ADDENDUM NO. THREE (3)

IFB NO. 2024-282

CONSTRUCTION, EMERGENCY GENERATOR FUELING SYSTEM REPLACEMENT

DATE: JUNE 17, 2024

FUEL PIPE REMEDIATION PLAN

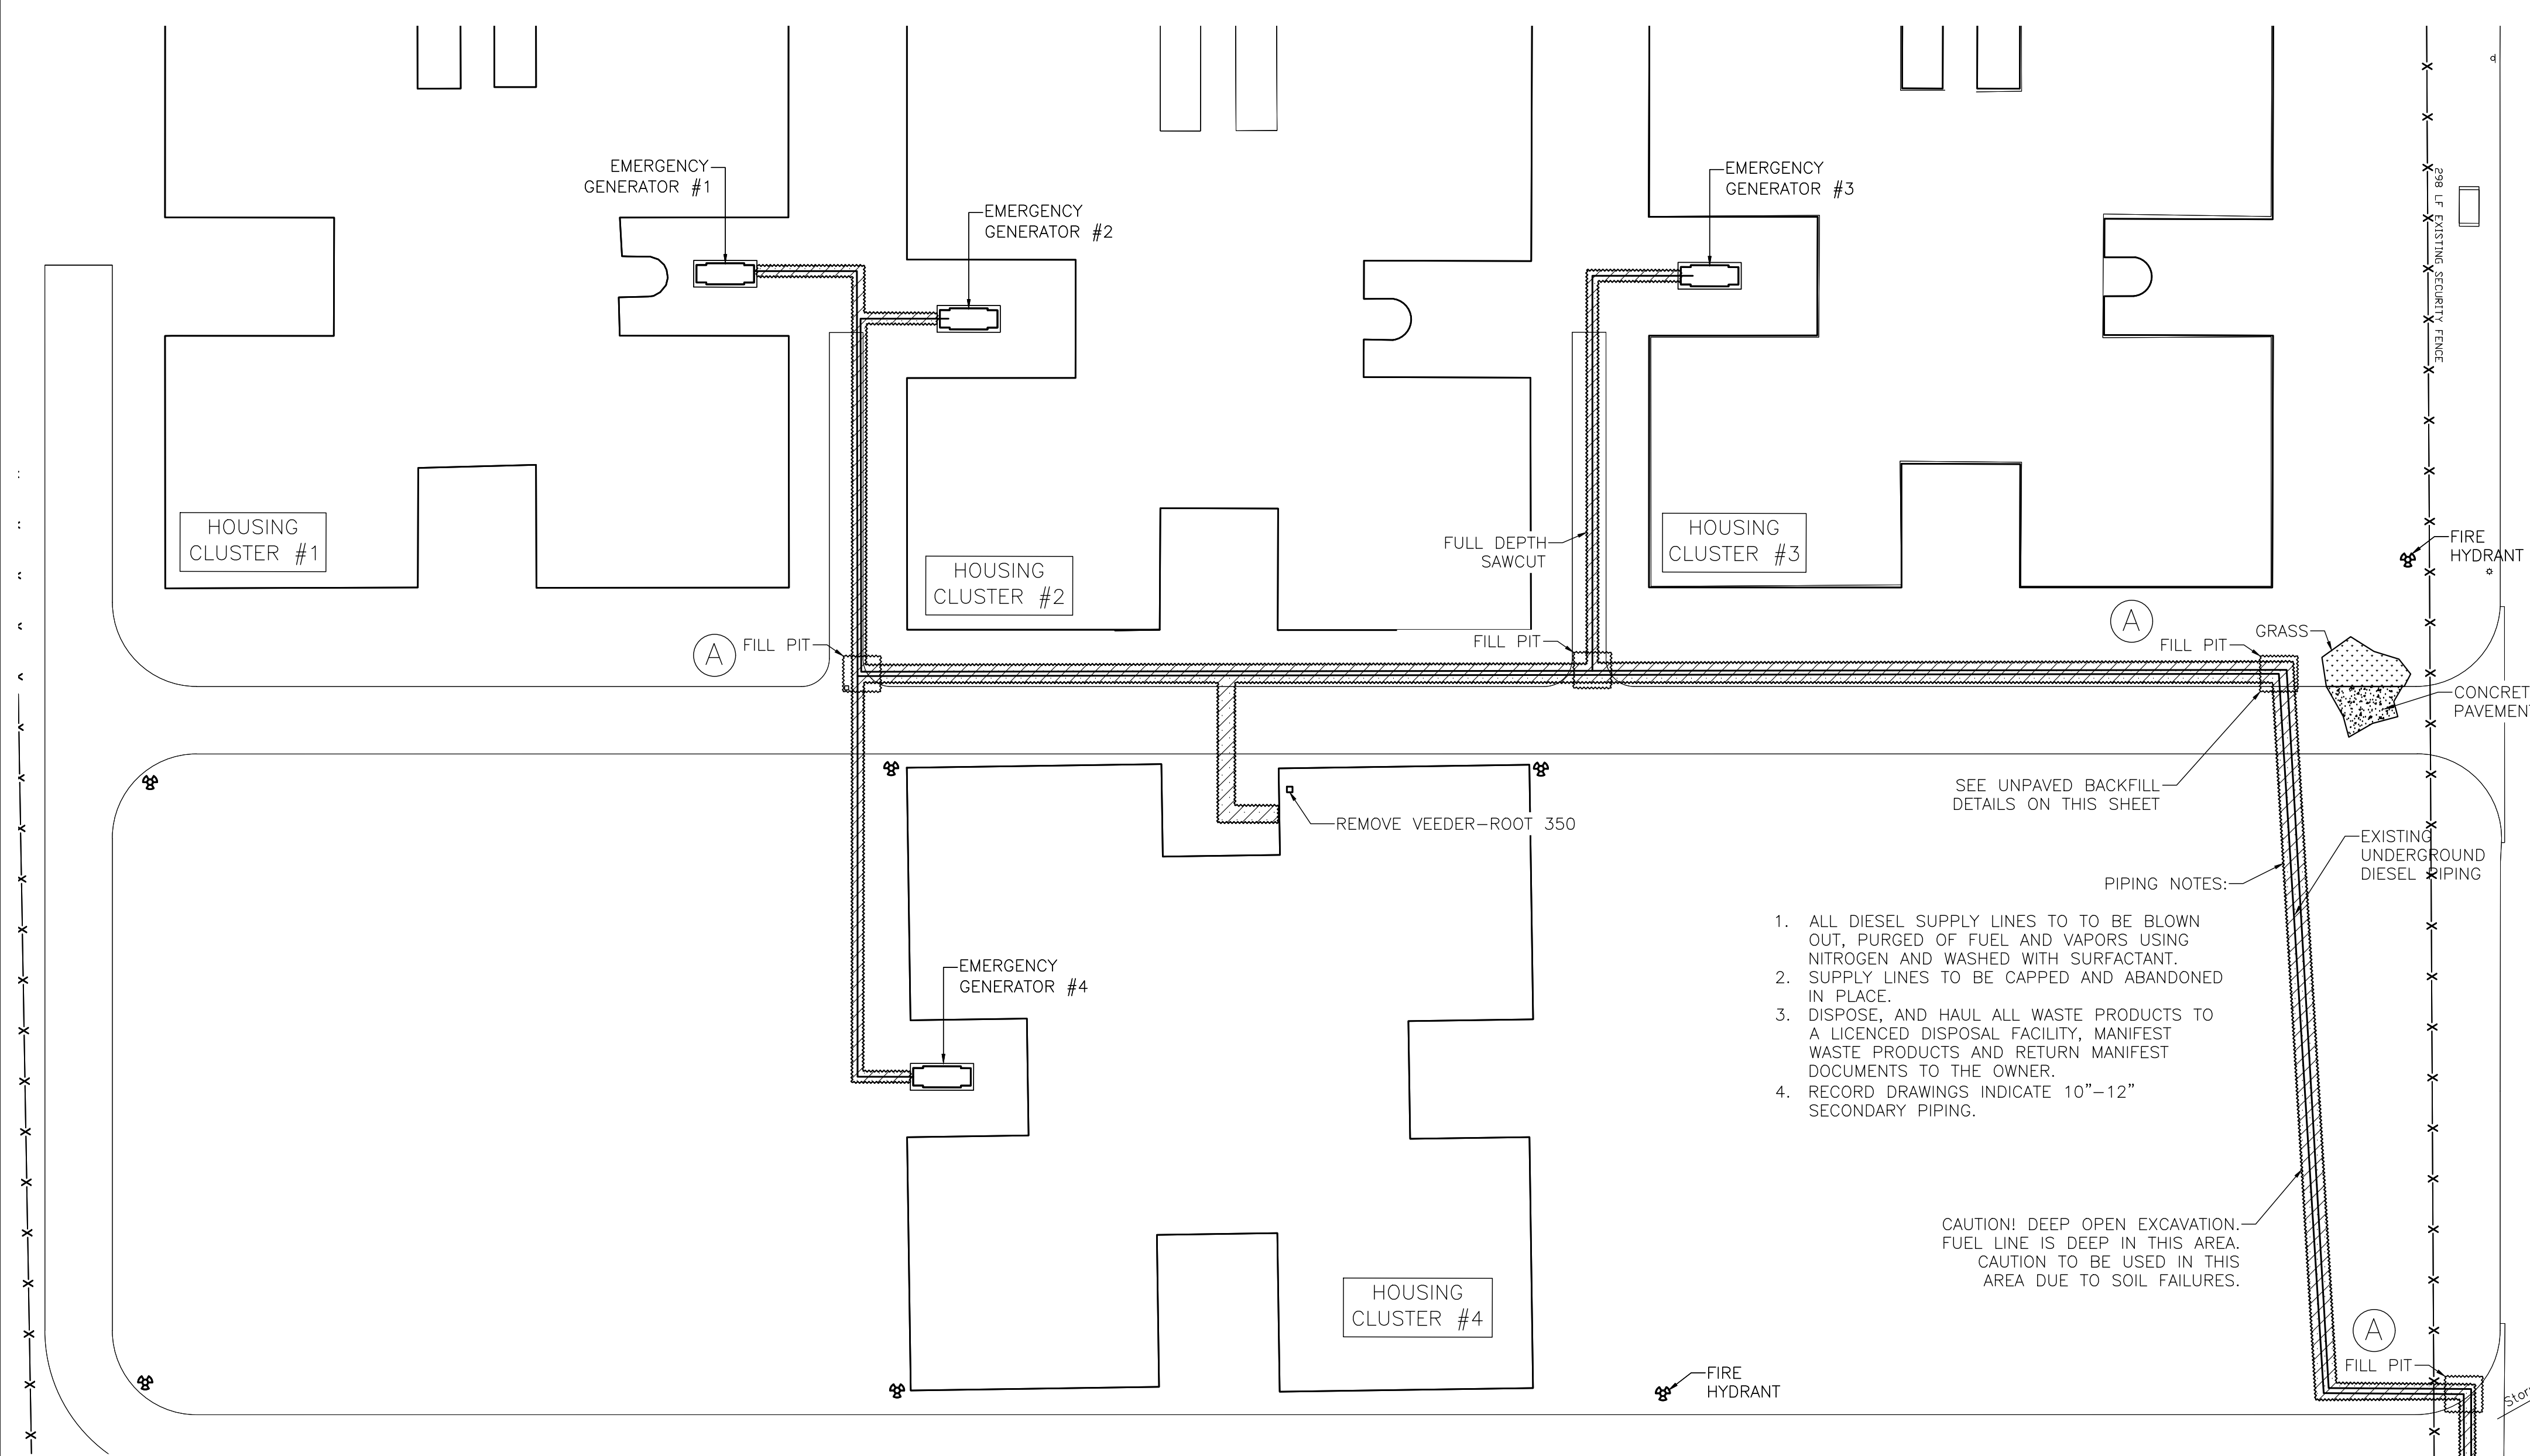
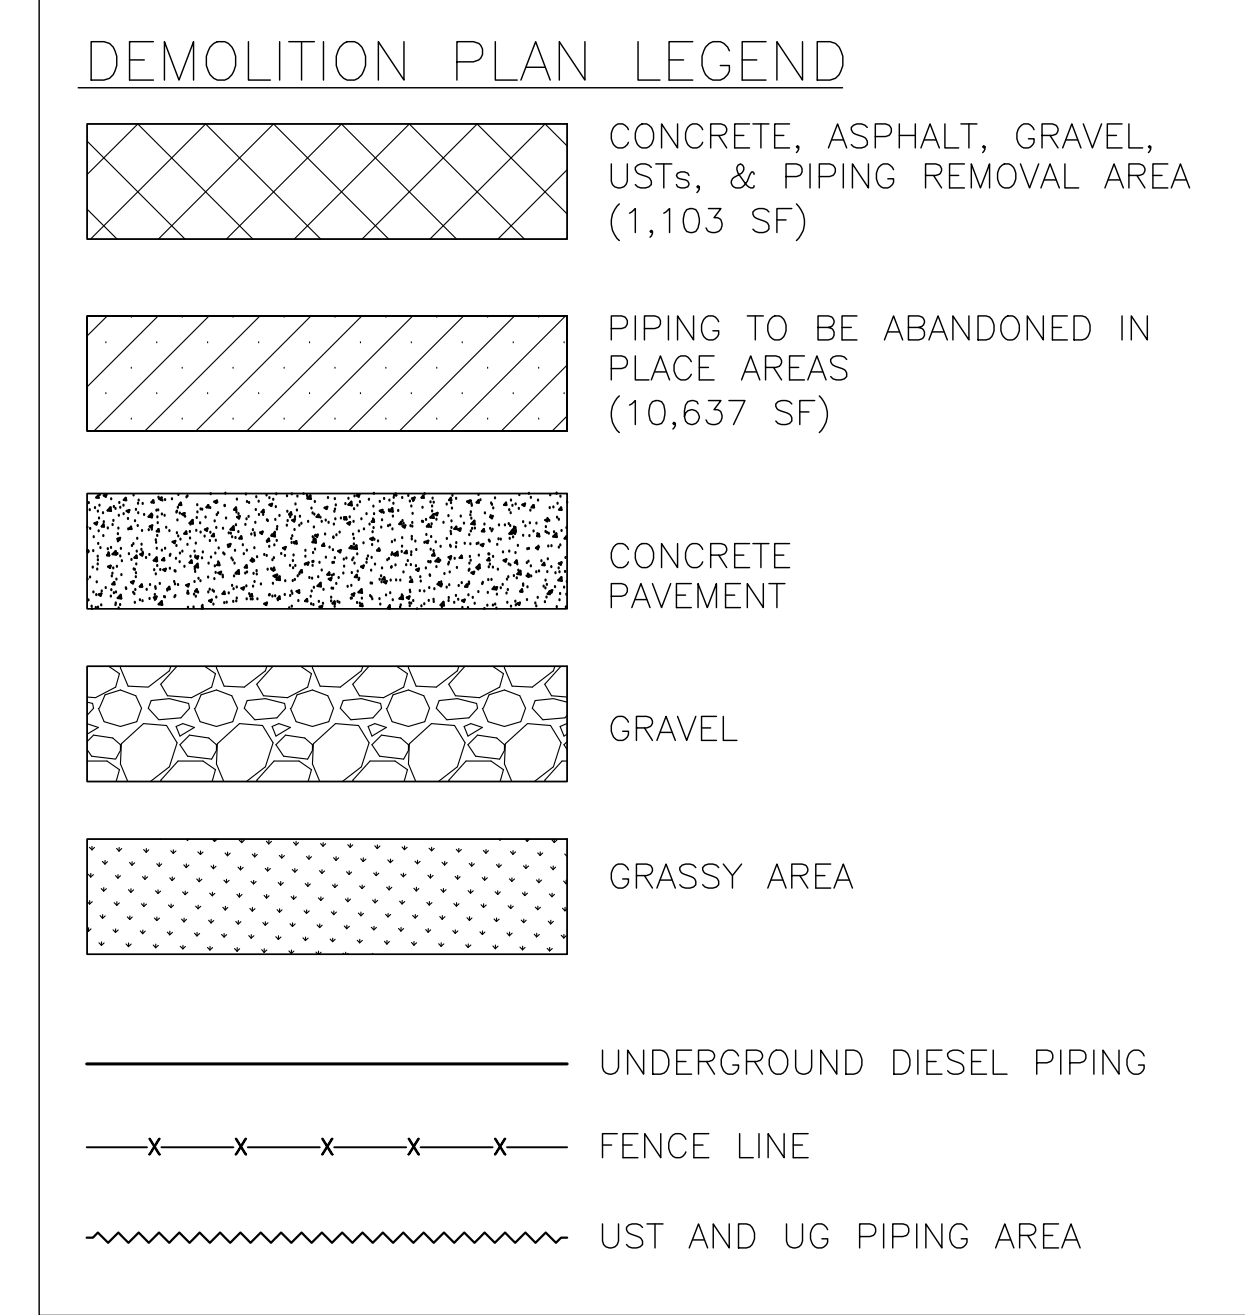
- PIPING NOTES:
- ALL DIESEL SUPPLY LINES TO BE BLOWN OUT, PURGED OF FUEL AND VAPORS USING NITROGEN AND WASHED WITH SURFACTANT.
 - SUPPLY LINES TO BE CAPPED AND ABANDONED IN PLACE.
 - DISPOSE, AND HAUL ALL WASTE PRODUCTS TO A LICENCED DISPOSAL FACILITY, MANIFEST WASTE PRODUCTS AND RETURN MANIFEST DOCUMENTS TO THE OWNER.
 - RECORD DRAWINGS INDICATE 10"-12" SECONDARY PIPING.

Question: Drawing 3 of 16 Piping Notes, still has verbiage about a washout and slurry fill. From meeting, this has been changed to blowout lines with inert gas and cap all lines. Please memorialize in your addendum.

Answer: Lines are not required to be filled with slurry. Lines shall be filled with inert gas and capped.
